U. S. NUCLEAR REGULATORY COMMISSION

Report No: 50-373/99020(DRS); 50-374/99020(DRS)

Facility: LaSalle Nuclear Generating Station, Units 1 and 2

LaSalle Nuclear Generating Station, Units 1 and 2
NRC Inspection Report 50-373/99020(DRS); 50-374/99020(DRS)

Figure 1. Representative Load vs Displacement Plot for 3/4-inch Concrete Expansion Anchor

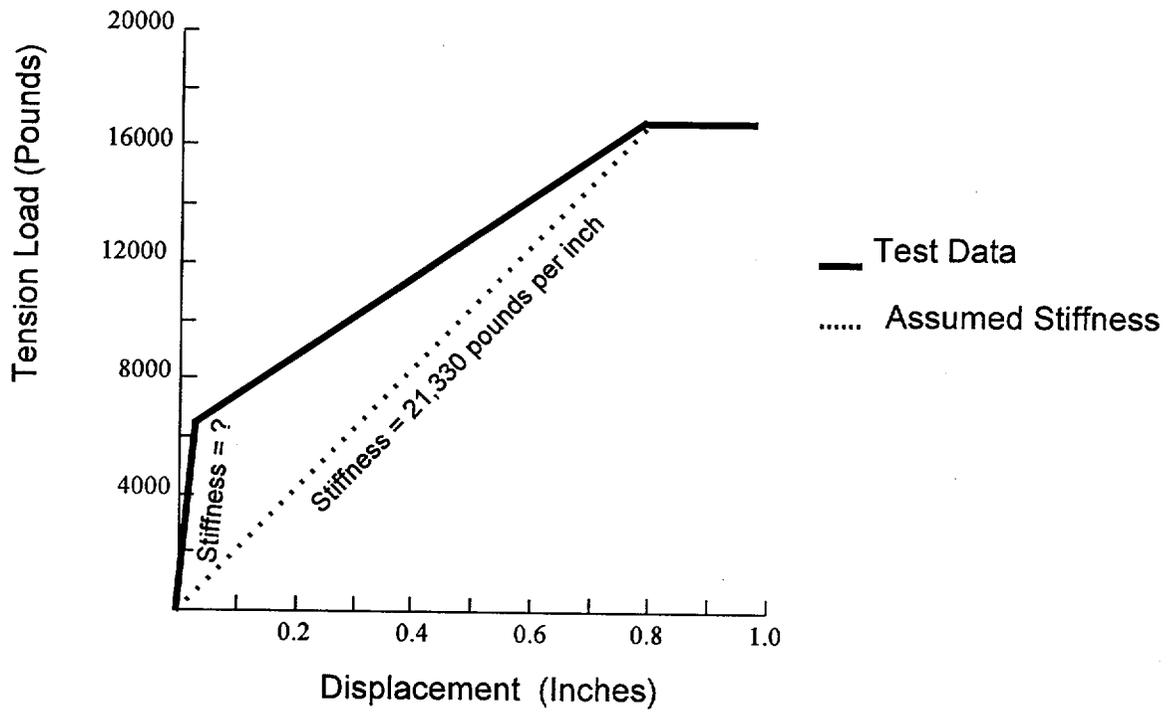
In reviewing analyses for detailed baseplate evaluations, the inspector questioned the relatively low stiffness value of 21,330 pounds per inch for 3/4-inch diameter concrete expansion anchors. In response, the licensee provided the load-displacement curve

from prior anchor bolt tests that was the basis for the stiffness value given in Structural Design Standard SDS E-11.0, "Hilti Kwik Bolt Design." An approximate representation of the load-displacement plot provided by the licensee is given in Figure 1 below. The anchor bolt stiffness value of 21,330 pounds per inch was roughly derived by using the anchor bolt displacement at the ultimate load. However, as can be seen in Figure 1, the initial portion of the load-displacement plot is a significantly steeper line compared to the assumed line, indicating a much stiffer behavior. Since allowable anchor bolt loads are defined as one-fourth of the ultimate load, the anchor bolt will not exhibit the flexibility assumed in the licensee's calculations unless the anchor bolt load substantially exceeds the allowable load. In some applications, significantly underestimating the anchor bolt stiffness will result in underestimating the anchor bolt load, potentially affecting the design adequacy of the support. The failure to verify the adequacy of design is a violation of 10 CFR 50, Appendix B, Criterion III, "Design Control" (50-373/374-99020-02). This Severity Level IV violation is being treated as a Non-Cited Violation, consistent with Appendix C of the NRC Enforcement Policy. This violation is in the licensee's corrective action program as PIF L1999 - 04779.
